## Appendix E

# Comments on the Draft Environmental Impact Report and Responses to Comments

Figure 1. Prairie falcon radiotelemetry locations, 2006-2008. Locations for individual prairie falcons indicated by different colors (N = 13 falcons). Note extensive overlap and use of the northern APWRA by up to six different falcons. Falcons nesting up to 10 miles away from the APWRA still use it.

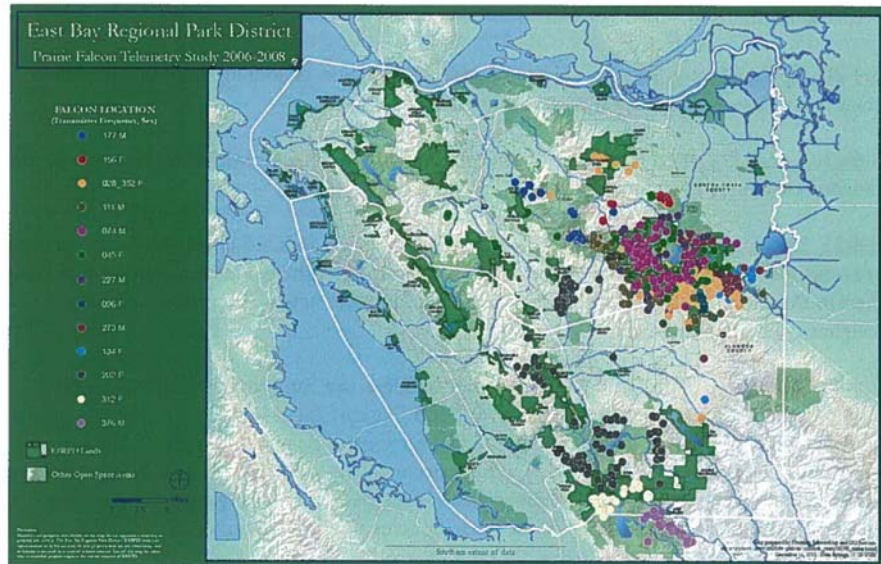
<u>p. 3.4-37. Prairie falcon.</u> Draft PEIR mislabels this species as a "APWRA focal species". Suggest relabeling as "a species of local conservation concern in the APWRA". There are at least four recent, known nest sites located within the (two county) APWRA and at least two more nest sites located within 2 miles of the program area (EBRPD data). In addition, radiotelemetry data on prairie falcons indicates extensive use of the APRWA by falcons nesting more than ten miles from the program area (EBRPD unpublished data, see Figure 1 below).	46

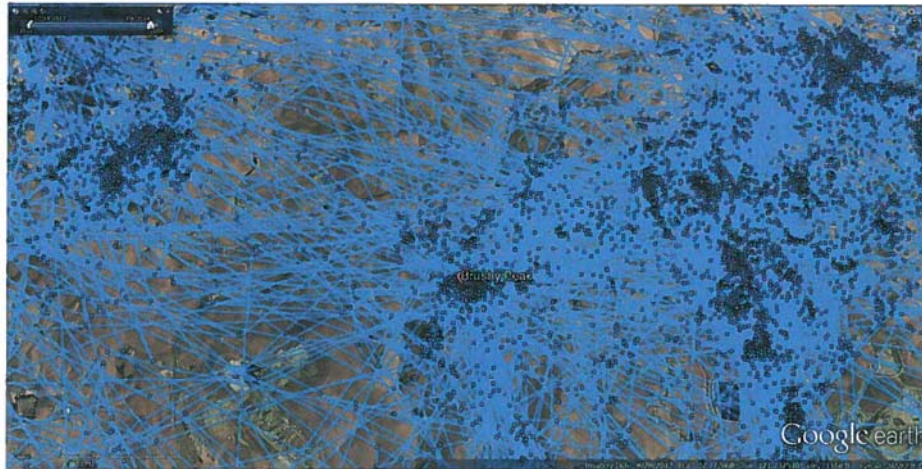
- One area that is heavily used by golden eagles in the APWRA is Brushy Peak. The peak and its vicinity are currently devoid of wind turbines. The EBRPD has been tracking golden eagles using GPS/GSM transmitters and current data show that Brushy Peak is a major concentration location for golden eagles (see Figure 2, below) and may represent a communal roost location. Future repowering plans should avoid placing turbines within established buffers around Brushy Peak to provide a turbine-free environment for eagles using Brushy Peak and lower the risk of golden eagle/wind turbine blade strikes. 59

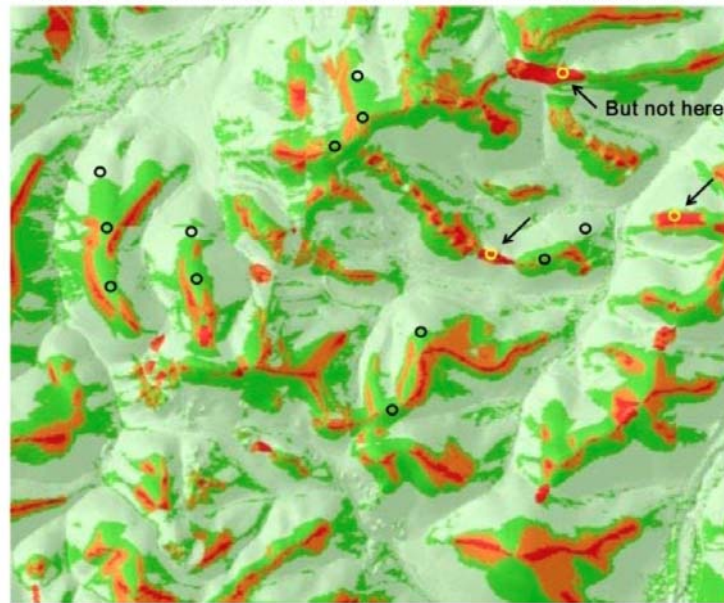
It is also extremely important that the EIR detail the oversight that will occur throughout the repowering process to ensure that micro-siting using the best available science does actually occur. This would be associated with ensuring that Mitigation Measure BIO-11b is binding and enforceable. A simple way to accomplish this would be to have County staff conduct inspections of wind energy repowering sites with siting model maps to ensure that turbines are being placed where models indicate low risk of striking focal raptor species.

Figure 1-2 Program Area

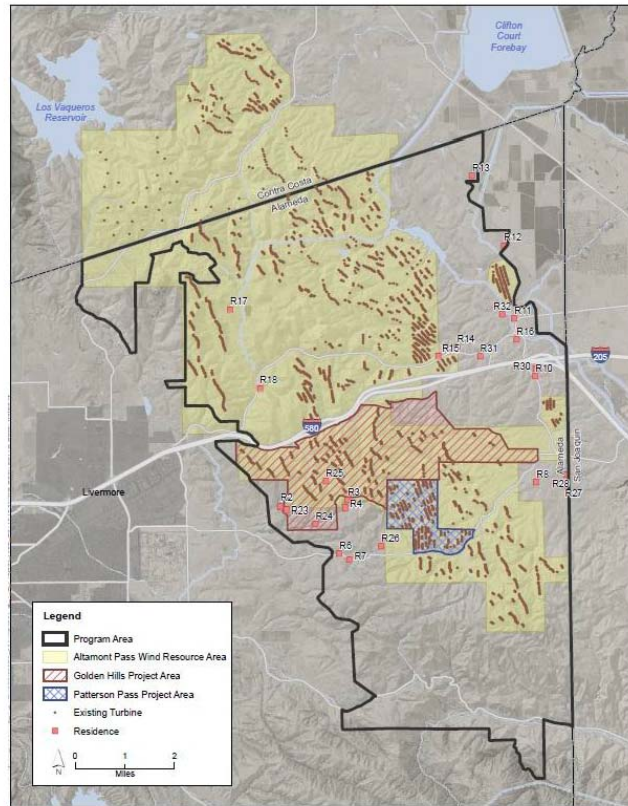
Section 2.1 in the dpEIR describes how a new boundary for the APWRA was developed during the incomplete NCCP/HCP process, and that this “revised boundary” is used to define the program area. It also states that “repowered wind turbines may be constructed anywhere within this revised boundary.”

We believe this is an inaccurate and inappropriate way to define the Program Area for the APWRAR because the NCCP/HCP process was never completed and the “revised boundary” the dpEIR refers to was never finalized or put through a public review process. As Figure 1-2 (pictured below) in the dpEIR clearly shows, the Program Area includes large areas to the east and south of the current limits of the Altamont Pass Wind Resource Area. To propose that such a large area (≥30% or more of the Alameda County portion of the current Altamont Pass Wind Resource Area) could be opened up to wind energy development without public review is a major flaw that the EIR must correct. The EIR should be changed to redefine the Program Area and the area where repowered wind turbines may be constructed as the current official and accepted limits of the Altamont Pass Wind Resource Area.

The APWRA footprint is compared to the proposed program area boundary in Figure 1-2 of the Draft PEIR. Please also see Master Response 2, *Program Area Boundary*.
